Subject: Progress Energy Florida Levy Nuclear Plant Units 1 and 2

This letter provides additional clarifying information in response to comments raised in your letter to the DEP Siting Coordination Office, dated August 27, 2008. Please note that the attachments referenced in the response below are being provided to FWC and DEP Siting Coordination Office only.

Temperature vs. Distance from Discharge Canal

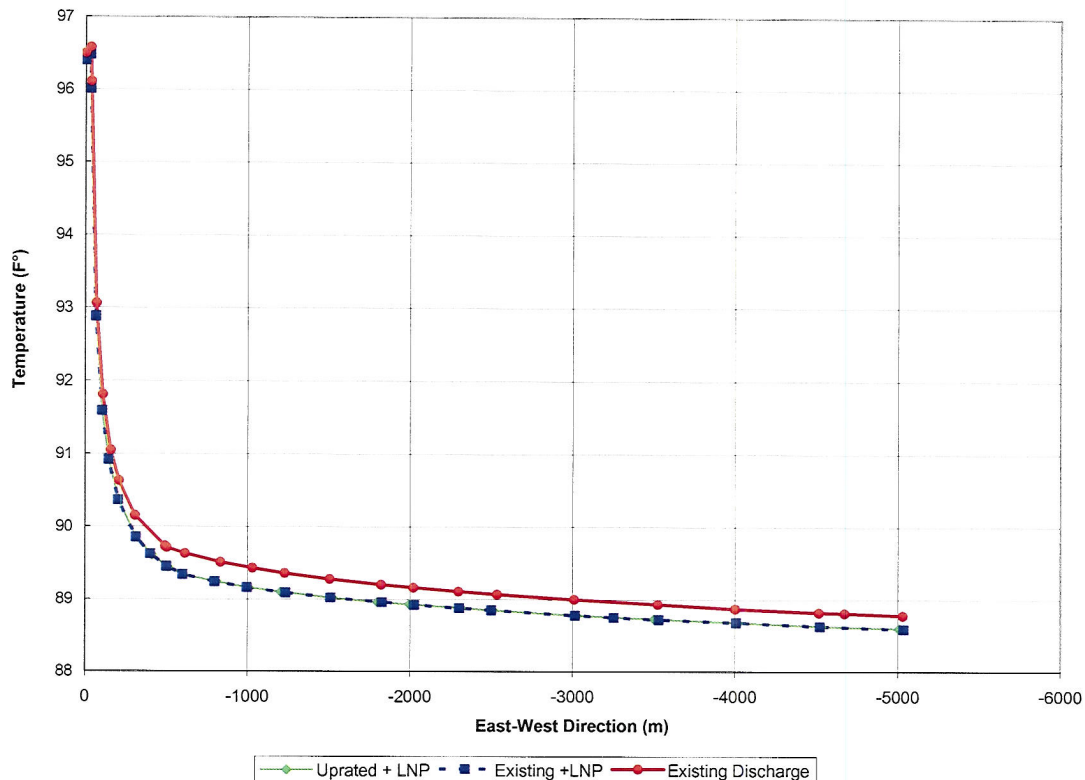
Progress Energy has provided the details of the "COLA Aquatic Sampling Workplan" dated March 2008 (RAI Number: LNP SCA RAI-I07). In the review of the workplan, it does not appear that benthic monitoring of seagrasses is planned or is being conducted. We request additional information on procedures that Progress Energy will employ to monitor impacts to seagrass beds. If no plan has been developed, we recommend that seagrass monitoring studies be incorporated into the workplan. Further, we recommend that these surveys should include: 1) seagrass species identification and location, 2) delineation of seagrass patch distribution if seagrass distribution is not continuous within the current and projected thermal plume, and 3) areal percent cover by species. We request that Progress Energy provide a map showing seagrass distributions by species (with densities or areal coverage) within the current and projected thermal plume.

The proposed LNP discharge will be a lower temperature than the existing CREC discharge and it will not cause or contribute to a greater thermal footprint in the zone of discharge at the end of the CREC discharge canal. As a result, the temperature of the combined LNP and CREC discharge is projected to be slightly lower than the temperature of the discharge from the existing CREC units. Discharge details are provided in the following table.

By adding the lower temperature LNP discharge, the overall temperature of the combined discharge plume is not expected to increase with distance. The 4 percent additional flow rate from LNP, with a lower temperature, will contribute to more dilution in the Gulf of Mexico. The existing CREC plume stratifies into a shallower surface layer because the higher temperature plume is slightly less dense than ambient Gulf waters. The more stratified existing condition results in more buoyant lateral spreading (i.e., the plume would be "squeezed" into a thinner layer), resulting in a plume area with less vertical mixing, covering a larger area. Adding the LNP discharge to the CREC discharge stream will cause the combined plume to be slightly denser because of lower temperature and slightly higher salinity. There will be slightly more vertical mixing under the proposed conditions, which will result in a more rapid reduction in temperature over distance and a smaller area of dispersion. The comparison between the existing and proposed discharges, as estimated with plume dilution modeling, indicates that the addition of the LNP discharge to the existing CREC discharge will have no significant or discernible effect on the thermal footprint of the CREC discharge, as illustrated in the following figure.
